### ADDENDUM NO. 1

### City of Mercer Island, Washington Public Works Facility Retrofit PROJECT NUMBER 24-41

DATE OF ADDENDUM ISSUE: December 12, 2024

HIGH ROOF FRAMING PLAN ALT 1

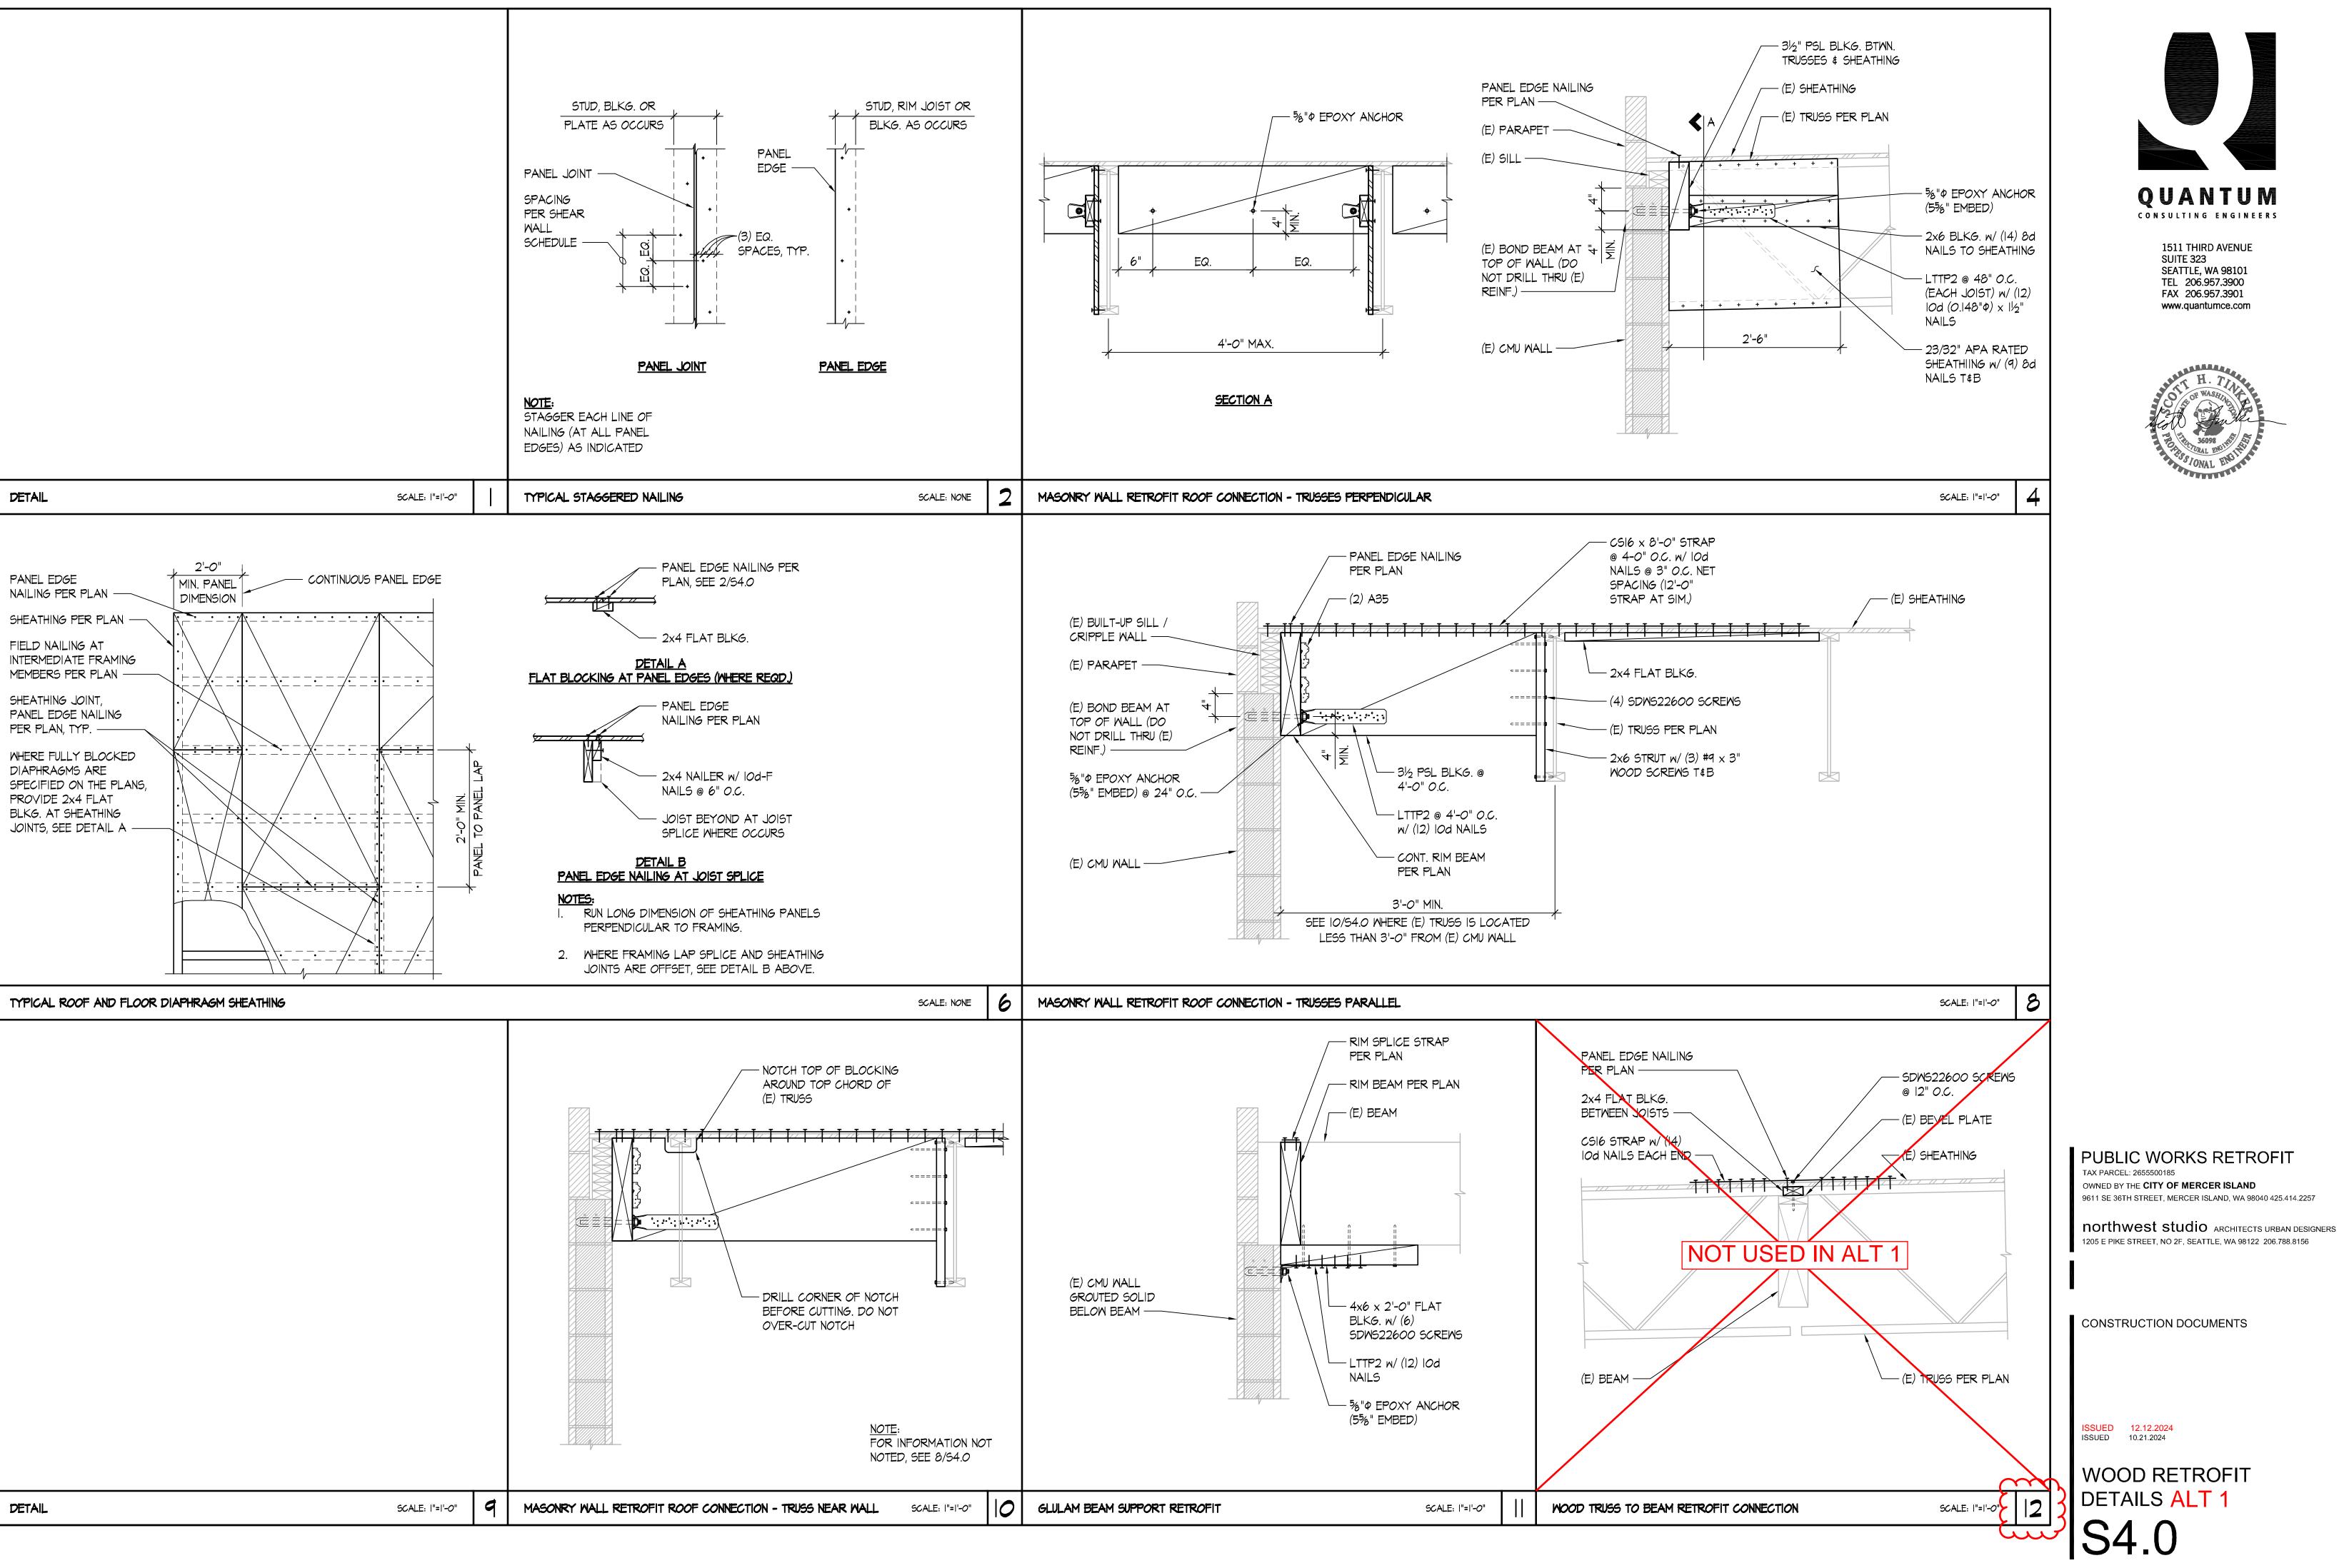
- 4. Sheet D-102.00 shows the roofing is removed around the perimeter at the (2) wood roof structure areas; sheet S2.2, notes 4 and 5, seem to indicate that existing plywood sheathing for the entire roof structure at these (2) areas is to be re-nailed. Please confirm if this is correct and if so, wouldn't the roofing at these areas need to be removed and replaced?

Sheets A2.2 Alt 1 and S4.0 Alt 1 are attached in response to question 4 and provide additional direction for the area of roofing removal and structural requirements that allow the noted middle portion of the roof to be left untouched. Bidders shall indicate which of the following options listed below are made part of the submitted bid. Bidders shall indicate selection on the Bid Form, in the space provided for acknowledgement of the Addendum Number by indicating Addendum No.1 and either Option A or Option B:

- Sheet D-102.00 indicated removals for access as needed for coordination with required structural work, however the question points to needed clarification. The structural drawings were prepared recognizing that the entire roof could be re-roofed (for nail pattern requirement context, with trusses @ 48" o.c., the maximum allowed nail spacing per current Code is 6" o.c., but the as-built drawings specified only 12" o.c. at intermediate supports). Please see the attached Addendum 1 drawings (S2.2 Alt1 and S4.0 Alt1) for the design parameters that allows for the noted middle portion of the roof to be left untouched.

- Option A. A complete reroofing of the high-bay roof areas, excepting mechanical equipment curbs, adhering to the nailing pattern indicated on S2.2 and S4.0 <u>dated 10.21.2024</u>, or
- Option B. Retaining the middle portion of the roofing, adhering to drawings S2.2 and S4.0 <u>dated 12.12.2024</u> and made part of this addendum
